APPLICATION NO.	FILING DATE	FIRST NAMED INVENTOR	ATTORNEY DOCKET NO.	CONFIRMATION NO.
10/628,368	07/29/2003	Praba Kharan Baptist	2993-479US RM/JR/mp	5159

Office Action Summary	Application No.		Applicant(s)	
	10/628,368		BAPTIST ET AL.	
	Examiner		Art Unit	
	Timothy D. Collins		3643

DETAILED ACTION

Fig. 6

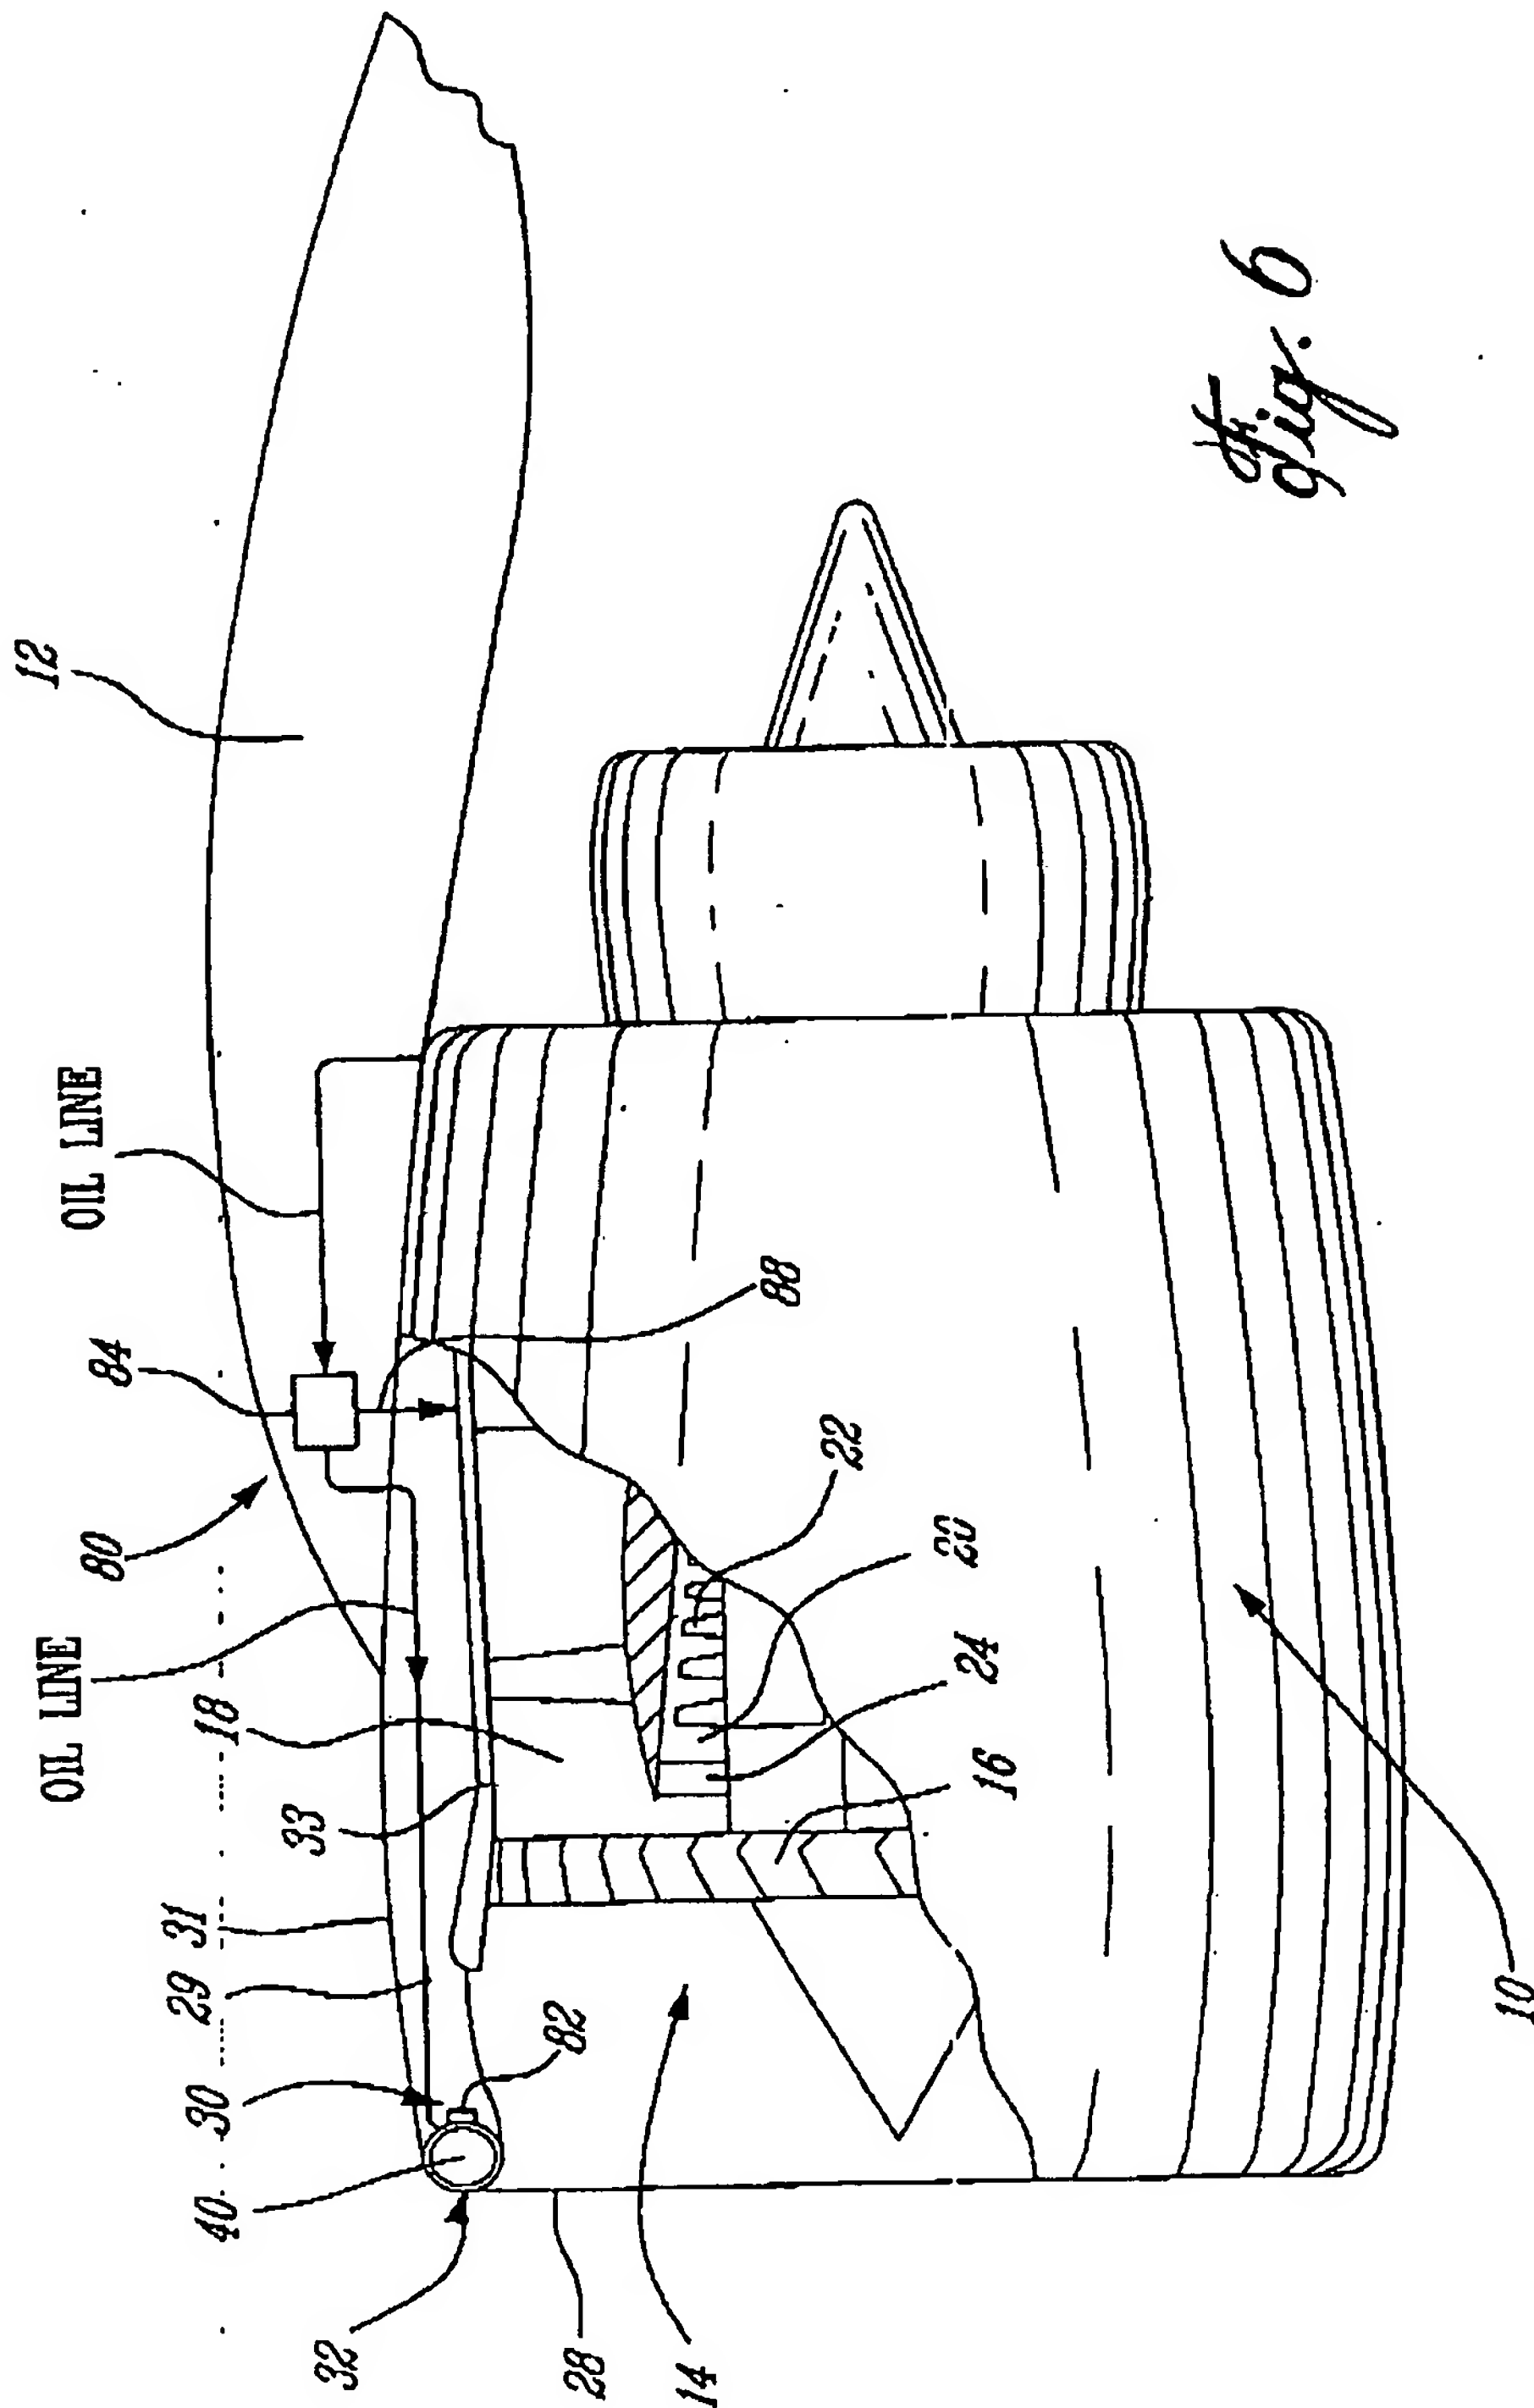
The drawings were received on 11/10/05. These drawings contain new matter and will not be entered.

New corrected drawings in compliance with 37 CFR 1.121(d) are required in this application because the new figure 6, which has not been seen previously contains new matter. The part number 82 is shown to be attached to the conduit 40 and this is the new matter. The examiner suggests that the applicant use a "black box" method to show the sensor. For example, the applicant can move the positioning of the part 82 to somewhere along the arrows from the part 84 to the part 40 and show the location more abstractly, because the applicant had not previously provided any details of the position of the sensor 82. Applicant is advised to employ the services of a competent patent draftsman outside the Office, as the U.S. Patent and Trademark Office no longer prepares new drawings. The corrected drawings are required in reply to the Office action to avoid abandonment of the application. The requirement for corrected drawings will not be held in abeyance.
